ADDENDUM NO. 1

THE PROJECT:
Town of Bennett
HWY 79 Widening Trail Project

PROJECT NO. 20-005

Drawing Sheet: L-9

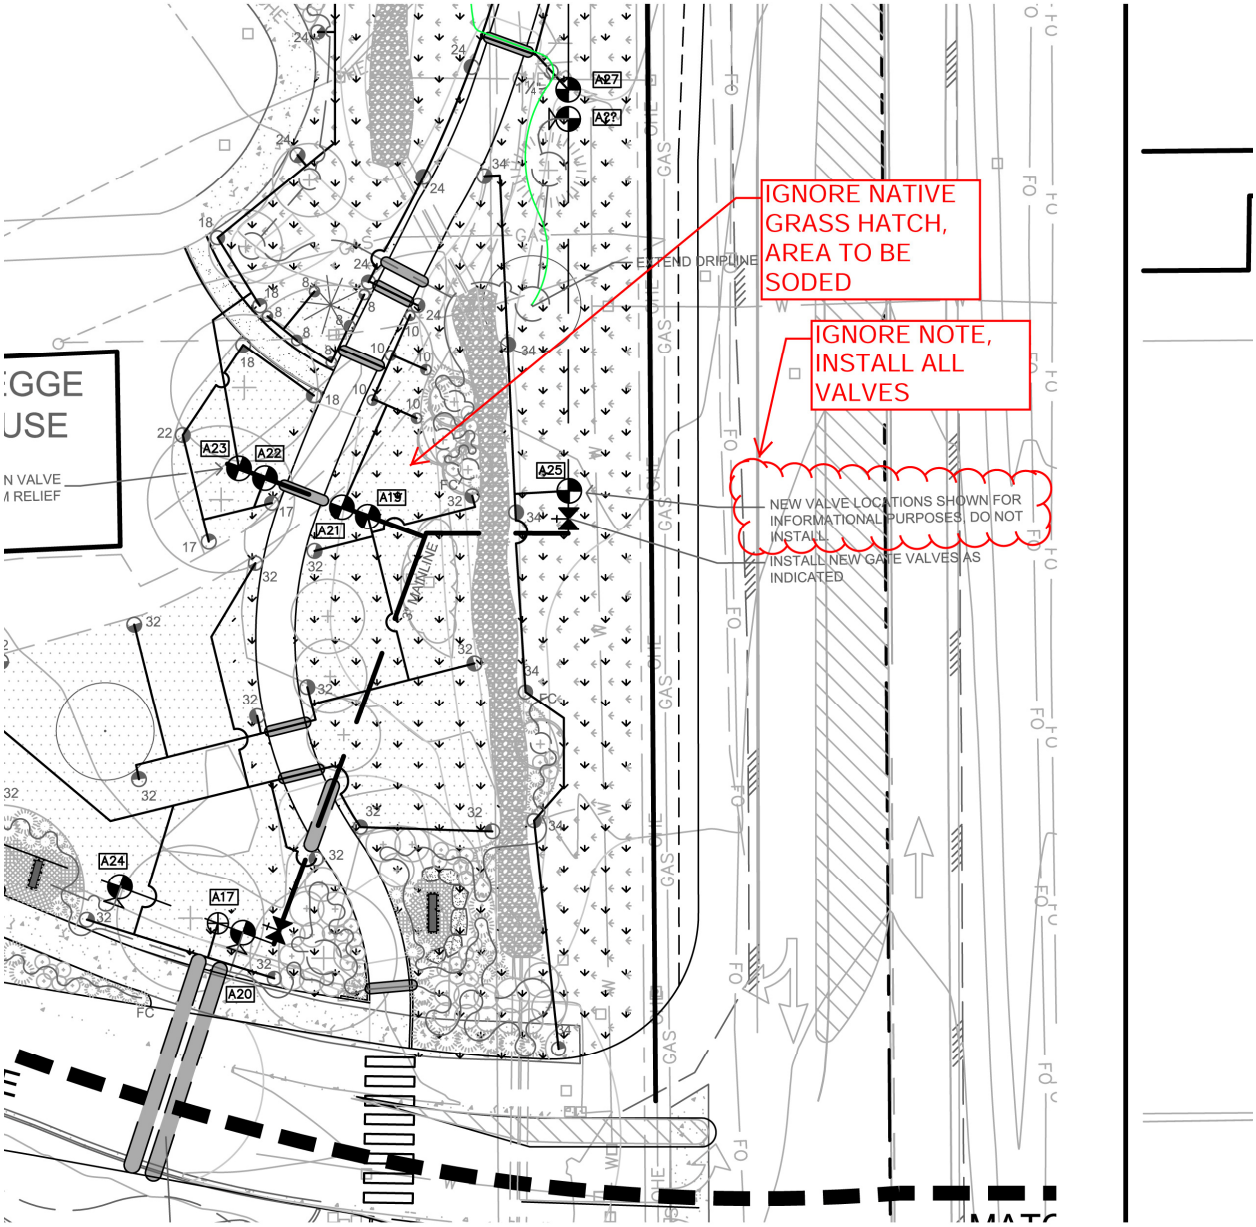
Actions: Ignore red clouded note below, all irrigation valves are to be installed.

Ignore seed hatch on Irrigation Plan, Use the landscape plan for areas to be sodded or seeded.
